SUMMARY OF CONCERNS IN RELATION TO THE PROPOSED NORTHCONNEX TUNNEL

SECTION A: THE CONNECTIVITY OF NORTHCONNEX SOUTHERN VENTILATION FACILITY AT THE SOUTHERN INTERCHANGE, THE SOUTHBOUND TUNNEL IN PARTICULAR

Figure 5-17 Motorway operations complex

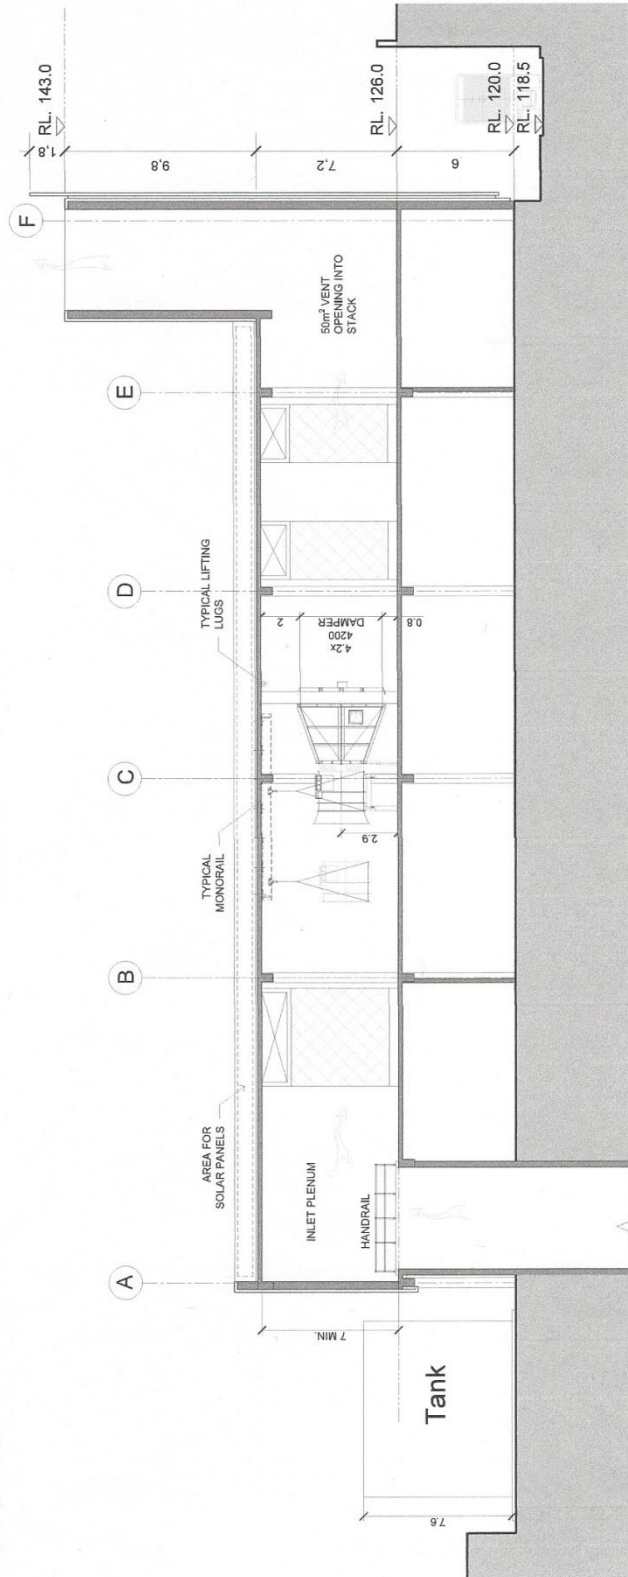
EIS Page 111, *Figure 5-17 Motorway operations complex*

Page 8 below there is no indication of how the ventilation facility will be connected to either the northbound or southbound tunnel, nor is there any indication of how the southbound exit portal onto Pennant Hills Road or the south-west exit portal onto the M2 will be connected.

MOTORWAY OPERATIONS COMPLEX - SOUTHERN VENTILATION FACILITY - SECTIONS
M1-M2-5000-DR-JD-0525

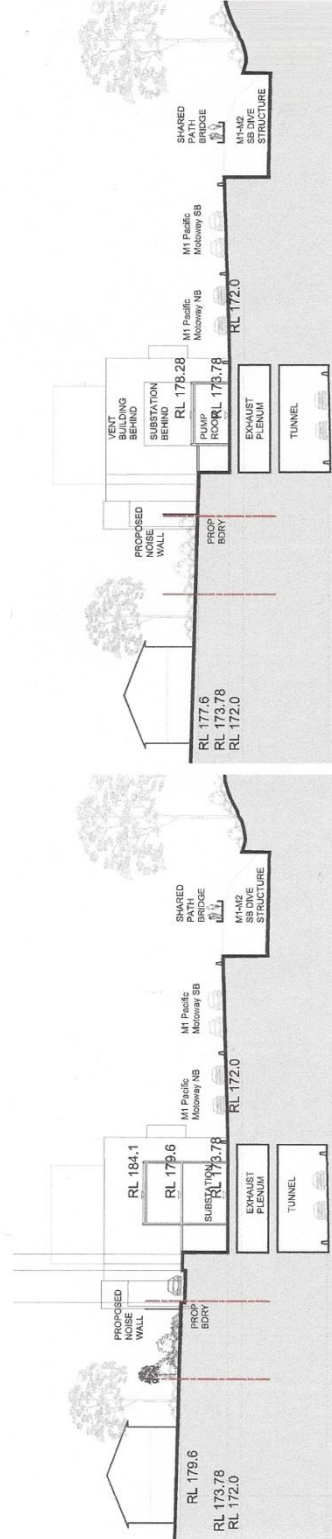
5. *EIS Volume 4, Technical working papers - Urban Design, 6.0 Operational Ancillary Facilities*
EIS Page 99 there is the diagram "Motorway Operations Complex – Southern Ventilation Facility – sections. *Page 10 below* The diagram has the cryptic label "Connection to tunnel TBC". What does TBC stand for? To be considered? Why is tunnel singular? Which tunnel is the diagram referring to northbound or southbound? There is no diagram showing any connection from the Southern Interchange ventilation facility to either the northbound or the southbound tunnel in any way
AND YET

- Diagrams need to be provided showing the inter-relation between the shaft, the ventilation outlet and the motorway operations centre with a clear description of what is to be constructed and how it will operate.
- The community needs irrefutable evidence that the polluted air from the southbound tunnel exit portals will not be allowed to flow like an invisible sewer through West Pennant Hills, North Rocks, Carlingford and Beecroft.
